Product Change Notification

1. ECR #: 221392
Notification #: 670

3. Series:
• 185 - 185 ST JACK FOR COMPRESSION MOUNT

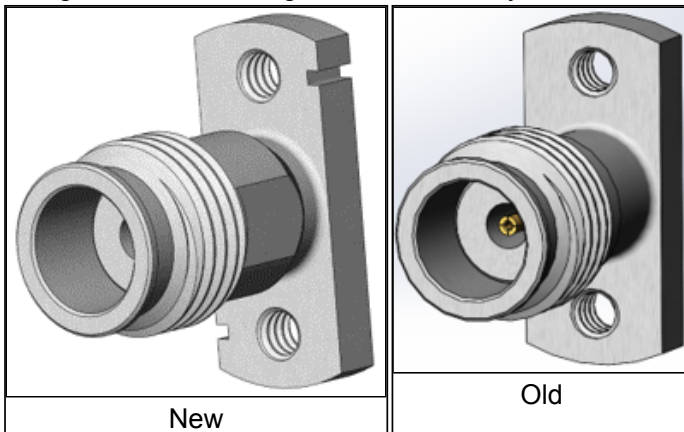
5. Description of Change:
We added two grooves on our body for PCB mounting alignment and a flange for our custom wrench to prevent rotation.

6. Method of Identifying Change
Two grooves and a flange on the new body

7. Reason for Change:
For better alignment onto the PCB

8. Impact of Change on Form, Fit, or Function:
• Form - Form change
